Access Compliance Report

Public Rights-of-Way

(Curb Ramps)

Intersection ID: 45182	Main Street: MAPLEHURST_DR	Cross Street: SOCIETY_ST	Location:	NW
ADA ID: 8B8F9E67C67D	Ramp Type: PerpDiag	Initial Pass/Fail: Fail	Overall Compliance: No	Severity Score: 10

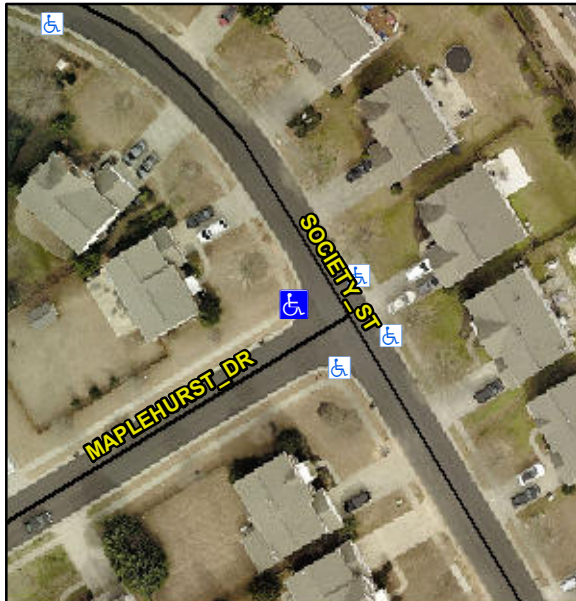
Not Found, R304.5.1, R304.5.3

Compliance	Description	Data	Compliance	Description	Data
N/A	Ramp Length (in)	96.0	Yes	Ramp Slope (%)	5.6
No	Ramp Width (in)	37.5	No	Ramp XSlope (%)	2.5
N/A	Flare Type LT	N/A	N/A	Flare Type RT	N/A
N/A	Flare Slope LT (%)	N/A	N/A	Flare Slope RT (%)	N/A
N/A	Flare Traversable LT?	N/A	N/A	Flare Traversable RT?	N/A
N/A	Landing Length (in)	N/A	N/A	DWS Provided?	N/A
N/A	Landing Width (in)	N/A	N/A	DWS Contrast?	N/A
N/A	Landing Slope (%)	N/A	N/A	DWS Length (in)	N/A
N/A	Landing X Slope (%)	N/A	N/A	DWS Full Width?	N/A
N/A	Landing Curb? (Y/N)	N/A	N/A	DWS Offset (in)	N/A
N/A	Shared Landing?	N/A			
N/A	Gutter Ponding?	N/A	N/A	Gutter Slope (%)	N/A
N/A	Gutter Lip Ht (in)	N/A	N/A	Gutter X Slope (%)	N/A
N/A	Painted X Walk1?	No	N/A	Painted X Walk2?	No
	X Walk 1 Direction	To SE		X Walk 2 Direction	To NE
N/A	X Walk 1 Width (in)	N/A	N/A	X Walk 2 Width (in)	N/A
	X Walk 1 Slope (%)	1.2		X Walk 2 Slope (%)	4.0
	X Walk 1 X Slope (%)	4.2		X Walk 2 X Slope (%)	0.8

Remove & Replace Curb Ramp With Two New Directional Ramps or Equivalent.
